NOV_SCE_ATJ_ 20211208-01

NOTICE OF VIOLATION

Energy Safety Inspection Report

Report Name: ATJ_SCE_20211208-01

Structure ID: 1008927E

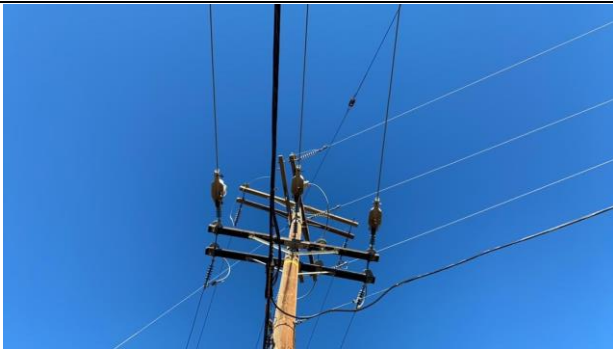
Item1Gimg1: Overall pole

Item1Gimg2: Pole ID

Item1IA1Img1: No vibration dampers

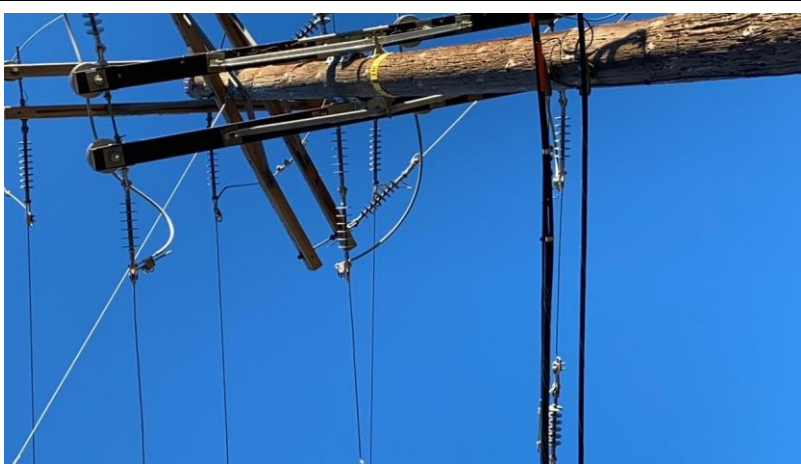
Item1IA2Img1: Guy wire is within 6 inches of bare conductor (top of photo, guy wire coming out of the picture)

Structure ID: 4920022E

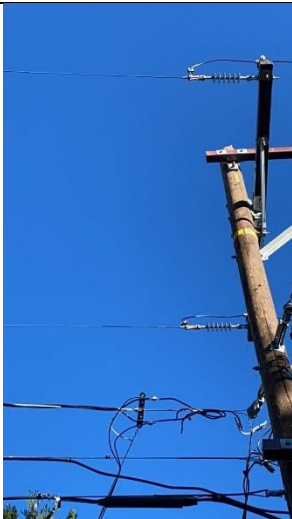
Item6IA1Img1: Bare wire

Item6CD9Img1: 3 splices on one phase
